RFIs on Circular Ties, Rotating Hooks, Staggered Lap Splices, and Closure Strips

RFIs 11-05, 11-06, 11-07, 11-08, and 11-09

Fig. 1: Construction details for circular ties in drilled shafts: (a) tie hooked around single bar; (b) tie lapped and hooked around separate vertical bars; (c) the Type 3 circular tie detail per Reference 2; and (d) the Type 3A circular tie detail per Reference 4 (1 in. = 25 mm)

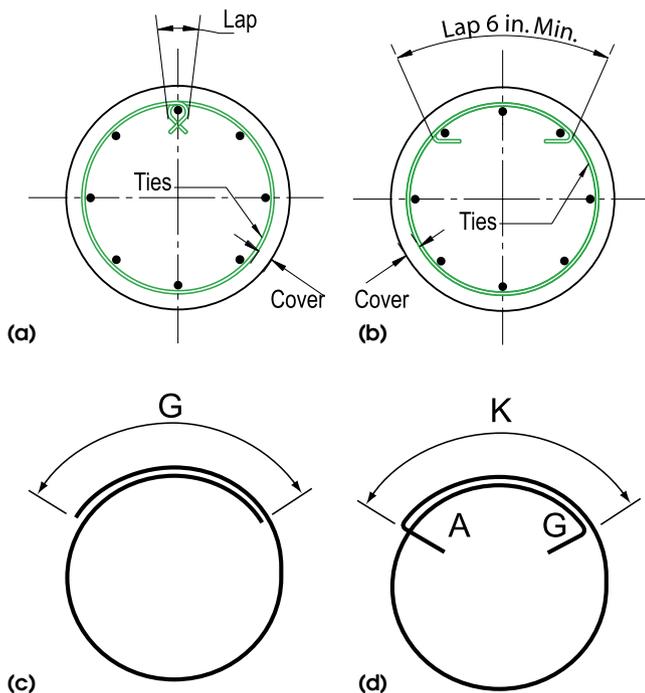
RFI 11-05: Construction details for drilled shafts commonly show the ends of circular ties hooked around a single vertical bar (Fig. 1(a)). Bar placement is slowed because a longitudinal bar must be threaded through the two hooks. We typically resolve this problem by estimating and detailing circular ties with ends partially lapped and hooked around two separate vertical bars (Fig. 1(b)). The longitudinal bar placement is simplified because threading isn't required. Also, because the alternate detail provides a short lap splice in addition to the hooked anchorages, we believe it is superior to the common detail. We were therefore surprised when, on a recent project, the cages assembled using the alternate detail were rejected by the Inspector, the Contractor, and the Engineer—all saying the original detail was better than the alternate we provided. Could you please comment?

Response: The timing of this RFI couldn't be better. Up through ACI 318-08,¹ Section 7.10.5.3 of the Code addressed circular ties with the statement: "Where longitudinal bars are located around the perimeter of a circle, a complete circular tie shall be permitted." A

Although this commentary didn't provide guidance for discrete circular ties, ACI 315-99² provides a Type T3 tie detail (Fig. 1(c)), showing a circular tie with end extensions. The end extensions are sufficient to provide a lap splice, so this is commonly interpreted as a complete circular tie.

In ACI 318-11,³ a complete circular tie has been explicitly defined with the addition of a new Section 7.10.5.4:

7.10.5.4 – Where longitudinal bars are located around the perimeter of a circle, a complete circular tie shall be permitted. The ends of the circular tie shall overlap by not less than 6 in. (152 mm) and terminate with standard hooks that engage a longitudinal column bar. Overlaps at ends of adjacent circular ties shall be staggered around the perimeter enclosing the longitudinal bars.

The requirements of the new ACI 318 section on circular ties closely match your alternate detail shown in Fig. 1(b). Therefore, your alternate detail should be acceptable, provided the circular tie lap is at

least 6 in. (152 mm) and successive circular ties are arranged around the perimeter so that the lap splices are staggered (that is, not engaging the same two longitudinal bars). It's anticipated that ACI 315 will be updated to supplement the Type 3 tie with a tie similar to the Type 3A tie currently used in Canada,⁴ as illustrated in Fig. 1(d).

Fig. 2: A standard DOT detail for complete circular ties, adapted from Fig. 6.6.4.1.2.2-1 of Reference 6

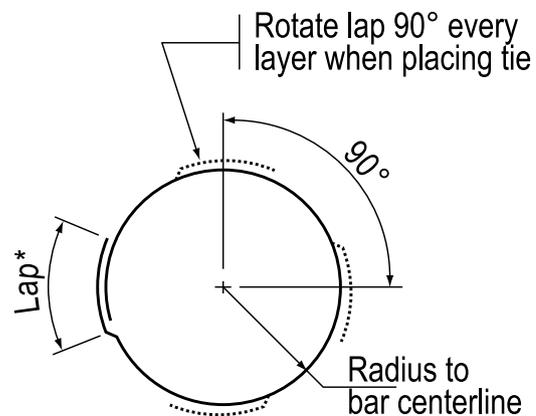
RFI 11-06: "Detailing Concrete Columns" (*Concrete International*, V. 33, No. 8, Aug. 2011, pp. 47-53) led to a discussion in our office regarding the required lap splice length for circular ties. As illustrated in Fig. 2, our state DOT office uses a Class B splice modified for the top bar effect and coating. We also require that the splices on alternate circular ties be rotated 90 degrees. Do the ACI or AASHTO codes specifically spell out the lap length requirements?

Response: The response to RFI 11-05 addresses the new ACI 318 Code provisions for detailing single, circular tie terminations. While the lap-splice detail you present was commonly considered to comply with previous Code requirements for a complete circular tie, it's not ideal from detailing and structural behavior perspectives, as spalling of the column cover (shell) concrete would be expected to expose the splice regions and eliminate the confining effect of the cover on the splice. The new Code provisions provide a much more positive anchorage. Should the concrete cover spall because of load, damage, or corrosion, the tie will remain effective in confining the longitudinal bars and column core.

To our knowledge, the AASHTO LRFD Bridge Design Specifications⁵ remain unchanged from your DOT detail (Fig. 2). However, the recent ACI 318 Code hook anchorage modification to the single circular tie

pattern provides a better tie detail, which we would recommend adopting given the reasons herein.

Fig. 3: Because the “A or G” dimension is 10 in. (250 mm) for a No. 5 (No. 16) bar (refer to Fig. 4), the restricted depth provided in this footing will necessitate rotation of the 90-degree hook extensions on: (a) the footing bars; and (b) the column dowels

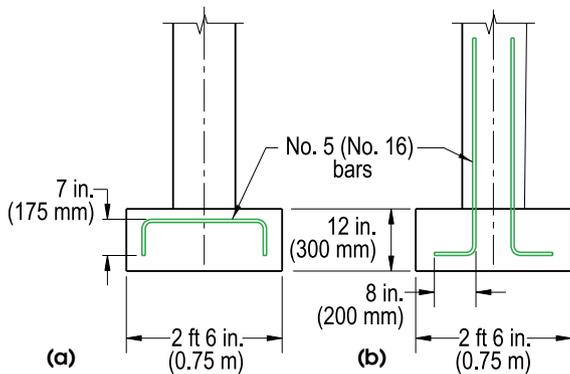
RFI 11-07: As a standard practice, we detail 180-degree hooks when a section is too shallow to allow adequate cover or hook extension for 90-degree hooks (Fig. 3). Alternatively, we detail 90-degree hooks with the hooks rotated to reduce the projected length of the hook extensions. Rotating the hooks is easily accomplished on vertical dowels, because the hook extensions are horizontal, and generally rest on and are tied to continuous bars. However, gravity will force the hook extensions for top horizontal bars, such as in slabs or footings, to rotate to the vertical, so each bar extension, if rotated, must be supported with spacers or tied to another “sacrificial” bar. Could you please comment?

Response: Section 12.5 of ACI 318 defines the same development length (ℓ_{dh}) for both 90- and 180-degree standard hooks, so a 180-degree hook can make for a better fit in tight places. As shown in

Fig. 4, the difference in the widths of the two standard hooks (the "A or G" dimension of the 90-degree hook and the "J" dimension of the 180-degree hook) can vary from 3 in. for a No. 3 bar (75 mm for a No. 10 bar) to 12.5 in. for a No. 18 bar (320 mm for a No. 57 bar).

Note that 180-degree hooks must be embedded in a section with adequate depth to provide proper cover over the hook end. This will likely not govern, but it needs to be checked. For example, if 90-degree hooks are replaced with 180-degree hooks (Fig. 3(b)) on column dowels, the dowels must be embedded deep enough into the footing to allow the hook ends to have the required concrete cover over the projecting tail of the hook. For cases like these, Table 1 provides the minimum embedment for 180-degree hooks to provide 2 in. (50 mm) of concrete cover beyond the hook.

If switching from a 90-degree hook to a 180-degree hook does not provide the required clearance, then rotating 90-degree hooks can be investigated. Besides the constructibility issues raised in the RFI, it's important to note that there are currently no provisions or guidance on how far hooks can be rotated or tilted without affecting their ability to develop the bars or compromising the performance of the reinforced concrete member itself. As an example, consider a slab with all the top bars at a support terminating in hooks. If all the hooks were rotated 90 degrees with the hooks lying in a single plane, would this arrangement cause a weakened, splitting plane in the concrete and lead to reduced performance? Perhaps.

Fig. 5: Lap splice options: (a) aligned; (b) staggered, with no gap; and (c) staggered, with a gap

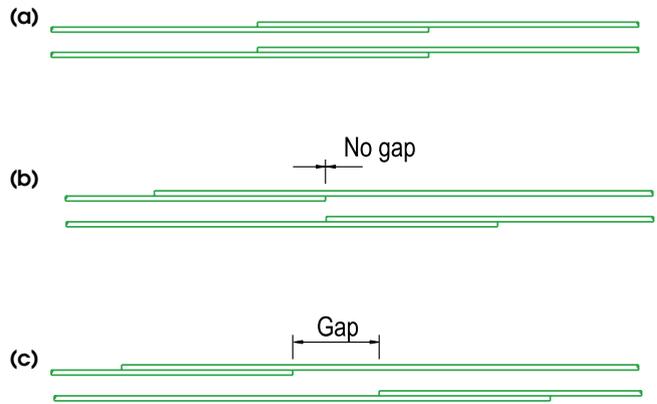
RFI 11-08: Rather than placing lap splices side-by-side (Fig. 5(a)), we detail staggered laps, as shown in Fig. 5(b). An alternate is shown in Fig. 5(c), where there is a gap between the lap splices. Does the configuration shown

in Fig. 5(c) have any advantages over that shown in Fig. 5(b)?

Response: Although there is no general requirement for the staggering of lap splices, ACI 318³ acknowledges the benefits of staggering by requiring staggered configurations of bars and splices under various conditions, as listed in Table 2.

Although it is allowed, the reinforcing bar layout configuration shown in Fig. 5(b) is not the most ideal. Because the bar ends of successive terminated bars are aligned, there is a strong tendency for a splitting crack to develop in the concrete, coincident with the bar ends. This is illustrated in Fig. 6(a). Transverse reinforcement in this region may provide confinement and help the situation, but providing a gap between the ends of the staggered lap splices is more desirable. The layout condition shown in Fig. 5(c) is better, as the crack width will be narrower if it develops at the bar ends. A condition similar to Fig. 5(c) is shown in Fig. 6(b).

According to Stöckl,⁷ the staggering of lap splices in beams (providing a “negative” gap, as shown in Fig. 6(c)) can reduce the width of flexural cracks at the ends of lap splices, provided that the stagger distance is at least one-half the lap splice length. For a Class A lap splice, with the lap splice length ℓ_{dl} equal to tension development length ℓ_d , the minimum stagger would be $0.5\ell_d$. This is illustrated in Fig. 6(c). For a Class B lap splice, with the lap length of $1.3\ell_d$, the minimum stagger would be $0.65\ell_d$. In either case, a closer stagger where the staggered regions overlap (a negative gap) provides the best structural behavior and will be consistent with the recommendations from Reference 7.
